**Report to
Development Permit Panel**

To: Development Permit Panel
From: Joe Erceg
Manager, Development Applications
Date: November 19, 2002
File: DP 02-202398
Re: **Application by Costco Wholesale Corporation for a Development Permit at
9151 Bridgeport Road**

TS1.1-01

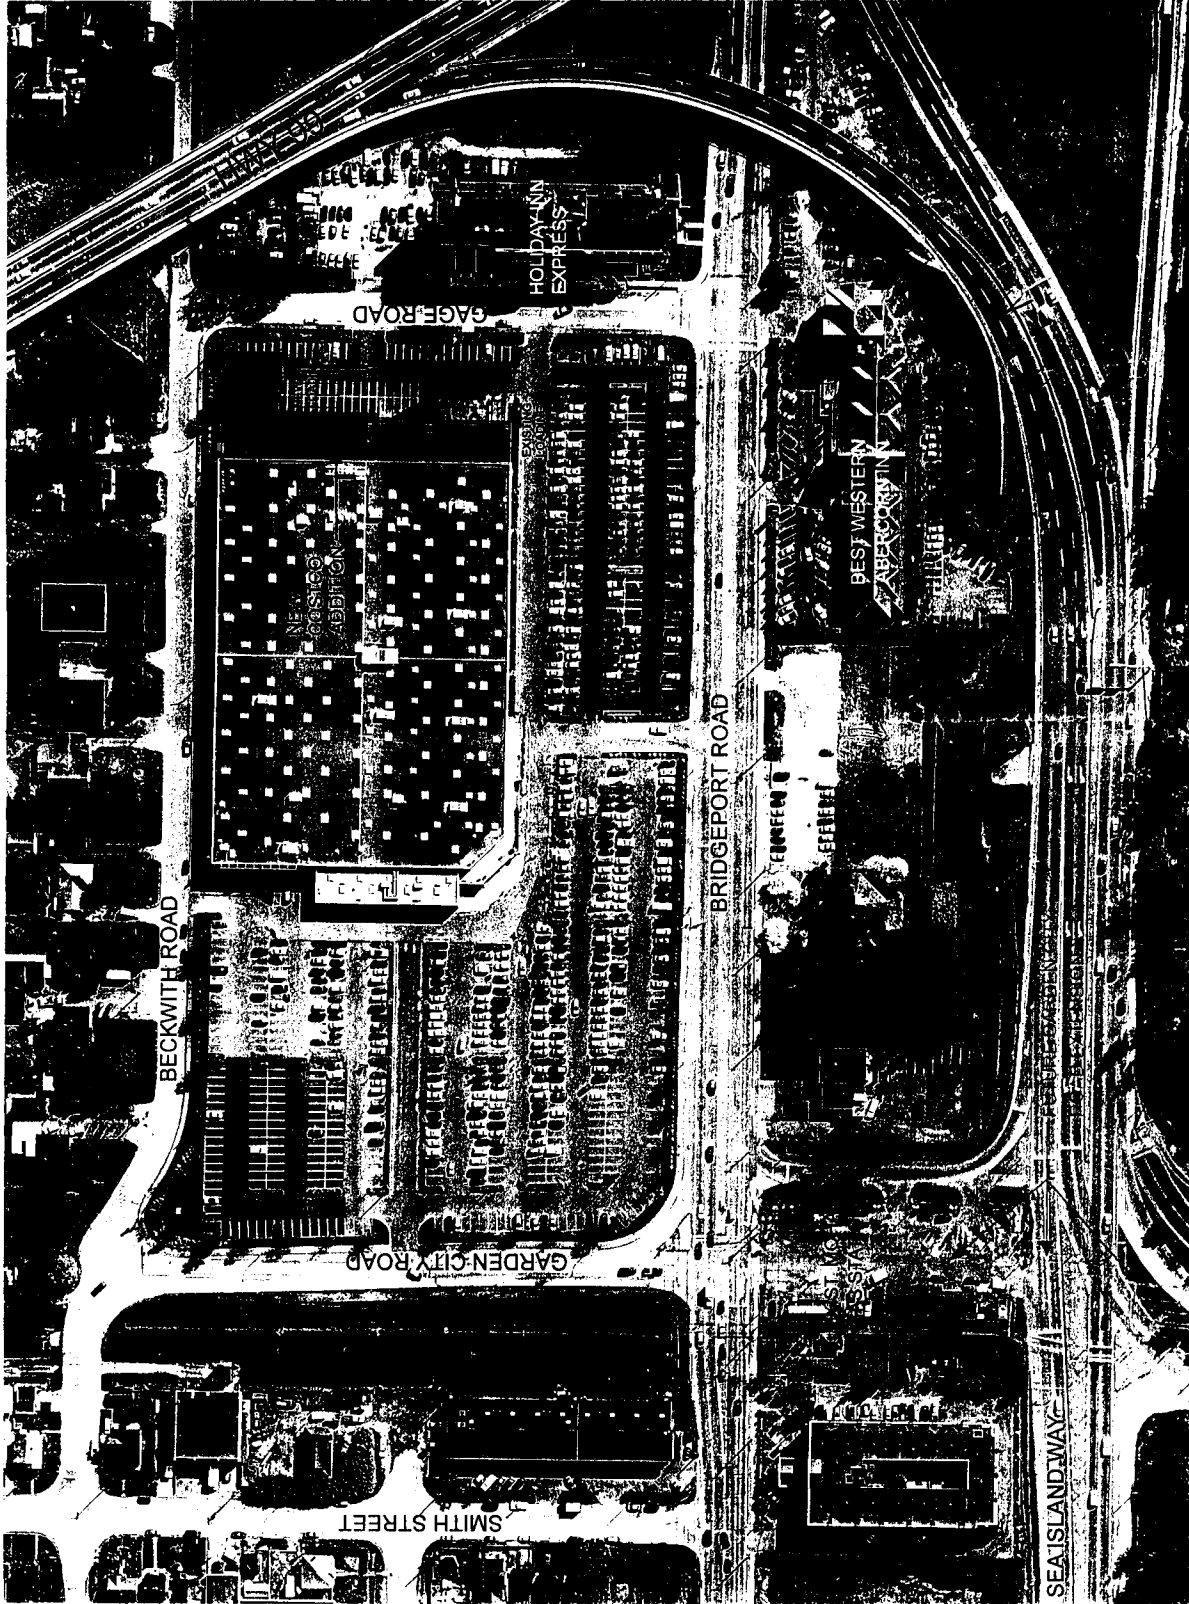
1. Provide a 'Context Plan' that indicates the existing conditions on the adjacent sites around the entire perimeter of the property. An aerial photo at an appropriate scale with proper annotations to describe the existing conditions of adjacency would be sufficient. ***See Sheet TS1.1-01 Site Context Plan.***

7. Finally, given the large flat roof and the location of this site under the flight path for the Vancouver International Airport, it is suggested that consideration be given to creating a graphic design or visual treatment on the roof top. For example, other recent developments along the flight path to the airport have included corporate identification and logos on their roof tops. Any roof top enhancement proposals that you may have are encouraged and will be welcome. *Costco will explore the possibility of creating a graphic design or other visual treatment on the roof. Please note that this might be challenging due to the large number of existing skylights and mechanical equipment located on the roof. See Sheet TS1.1-01 Site Context Plan.*

02-0221 A
NOVEMBER 11, 2002
SITE
LANDSCAPE PLAN
L 1.00

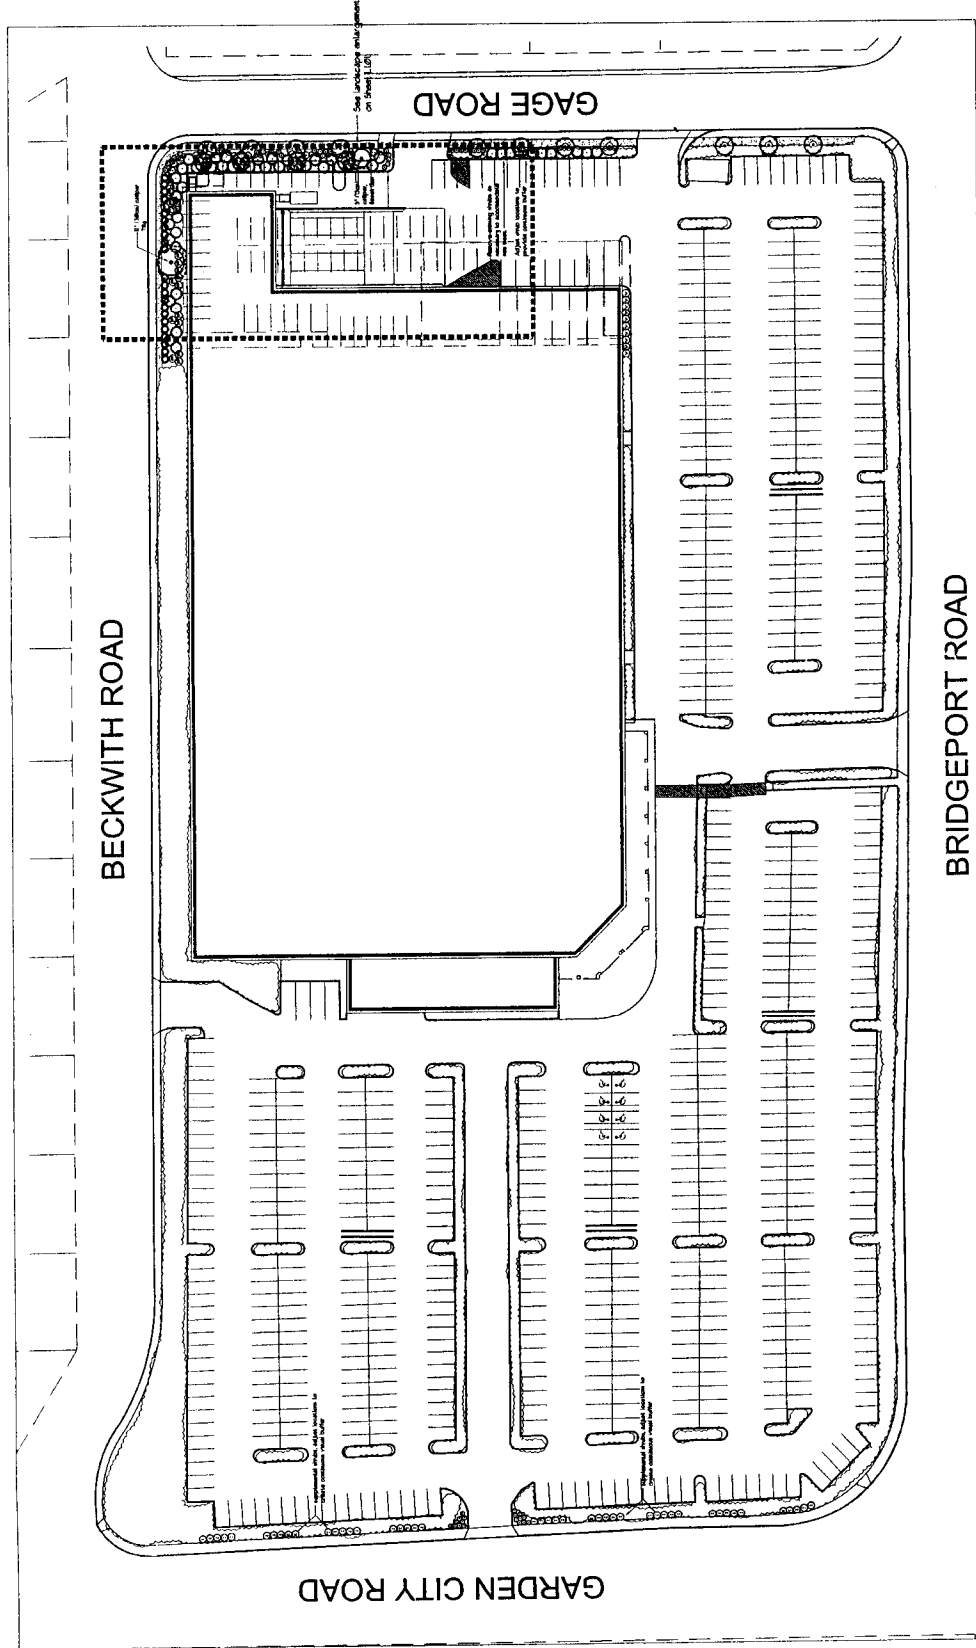
3. Provide a walkway connection from Bridgeport Road to the building entry that will serve the bus stop along Bridgeport Road. ***The applicant complies see Sheet L1.00.***

3. Provide continuous, broad-leaved evergreen shrub planting on the berm along Garden City Road to ensure a solid and dense mass planting of broad-leaved evergreen shrubs for the entire area between the back of the sidewalk and the parking lot curb and pavement. ***The applicant complies; see Sheet L1.00.***

93-0221 A
NOVEMBER 11, 2002
LANDSCAPE
PLAN
L 1.01

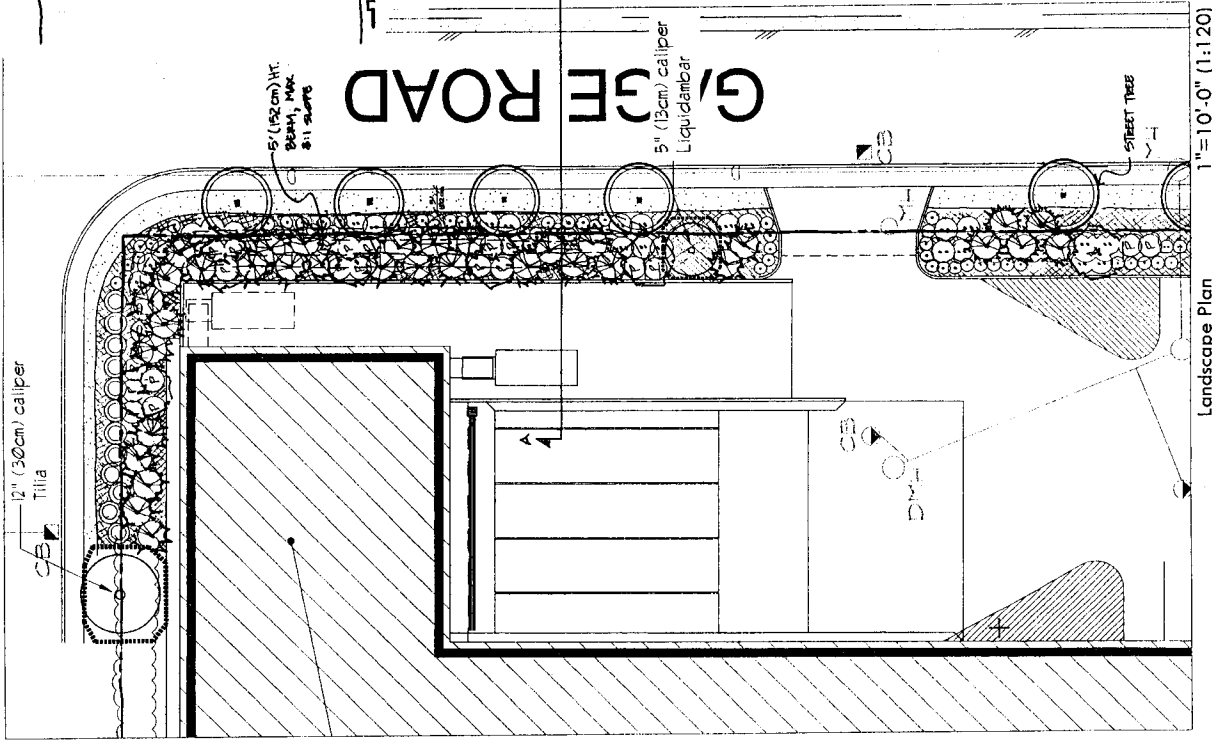
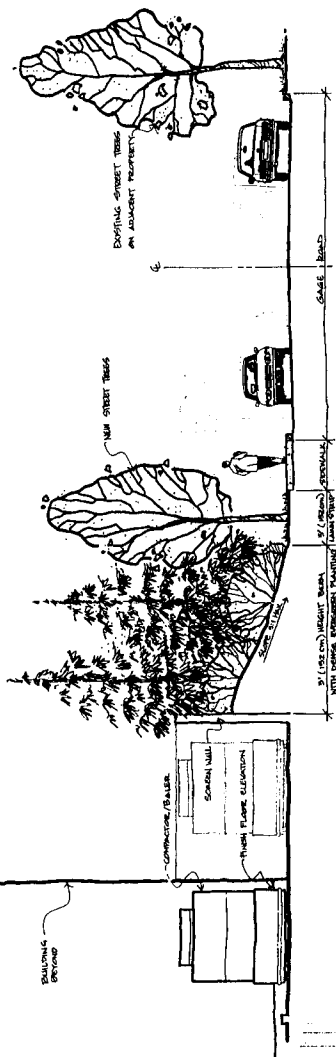
site prior to 6:00 a.m. *Costco will explore possible means of limiting truck deliveries before 6 a.m. Please also note that the relocated truck loading area as well as the relocated compactor and baler, will be no closer to and in some cases, further from the Holiday Inn Express than they presently are. See Sheet TS1.1-01 Site Context Plan for the relationship of the Holiday Inn Express in relation to the Costco site. With the addition of the screen wall, the berm, and the additional landscaping, the noise impact on the hotel should be significantly reduced over the current level. See Sheet L1.01.*

2. The boulevard treatment along Gage Road should include a 1.5m (5 ft.) high berm, complete with a retaining wall along the west side of this landscape buffer, complete with significant coniferous tree planting (i.e. minimum 3m height) and dense broad-leaved evergreen shrub planting to ensure a solid screen of the proposed loading bays from the hotel development on the east side of Gage Road. In addition, the landscape treatment along Gage Road should include continuous deciduous street tree planting (i.e. minimum 10 cm caliper size and approximate 7m spacing) along the west side of the sidewalk on Gage Road. ***The applicant complies. See Sheets L1.00 and L1.01.***

4. Continue the existing boulevard landscape treatment adjacent to the Costco building along Beckwith Road to ensure a solid screen of the proposed building addition on Beckwith Road. ***The applicant complies; see Sheet L1.01.***
